**REQUEST**

Current Zoning: R-5 (residential)  
Proposed Zoning: UR-2(CD) (urban residential, conditional)

**SUMMARY OF PETITION**

The petition proposes to rezone a .2 acre parcel to an urban residential district to permit the construction of up to two single family detached residential units at a density of up to 10 dwelling units per acre (DUA).

## PLANNING STAFF REVIEW

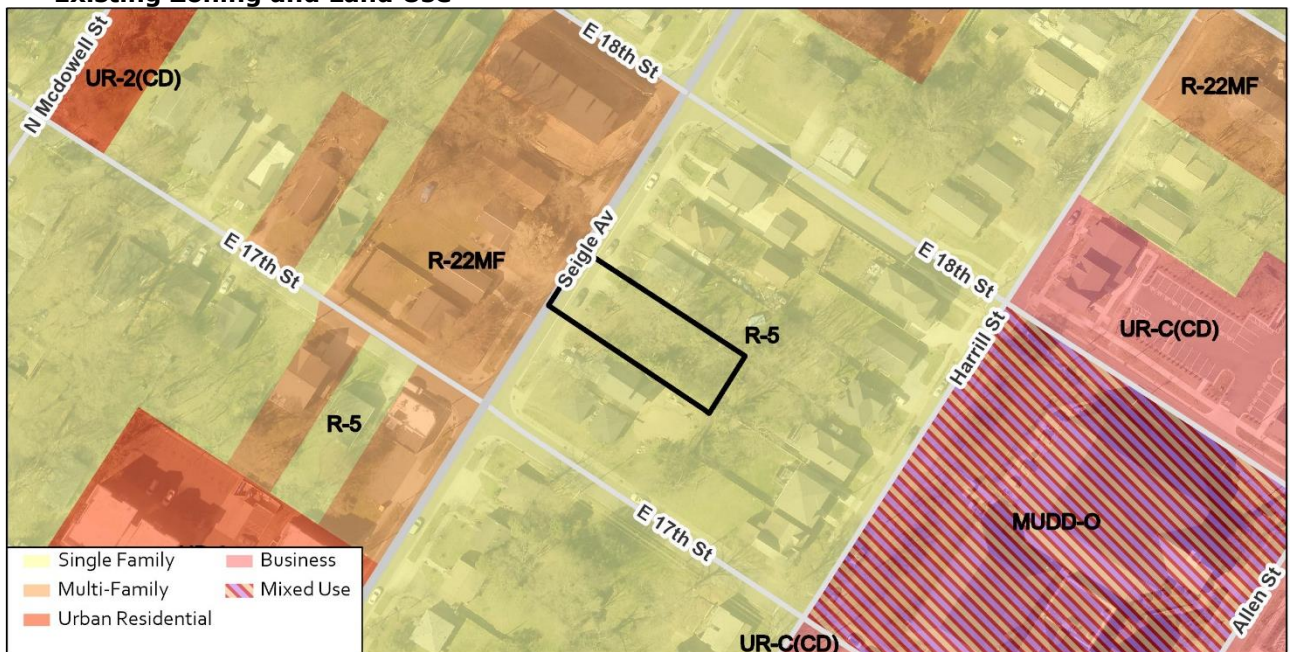
1. Clearly label the proposed ROW as “dedicated” to distinguish between the existing and the proposed ROW.
2. Although a commitment is made in the rezoning plan notes, the petitioner should properly illustrate the 8-foot planting strip and 6-foot sidewalk on the plan.
3. Add conditional note specifying dedication and fee simple conveyance of all rights-of-way to the City before the site’s first building certificate of occupancy is issued. CDOT requests rights-of-way set at 2’ behind back of sidewalk where feasible.

4. Correct scale so that reviewers may verify that setbacks are being met.

5. Add rezoning petition number (2021-007) in right hand margin of rezoning sheet.
6. Ensure that the reference to the garage setback where it states “garage setback from public R/W: 20’ from back of R/W or back of sidewalk, whichever is greater” is met on the site plan.
7. Remove the bullet in the development data table that makes reference to the maximum building height as it is repeated in the table above.
8. The development table notes that the minimum setback is 14 feet from future back of curb but site plan notes a different dimension. Please correct.
9. Note zoning of adjacent parcels.
10. Conditional note bullets should be numbered throughout the plan.
11. The subsection labeled “Streetscape and Landscaping” should replace current note with a note that reads “The petitioner shall comply with the requirements of the Zoning Ordinance and all other applicable city regulations.”
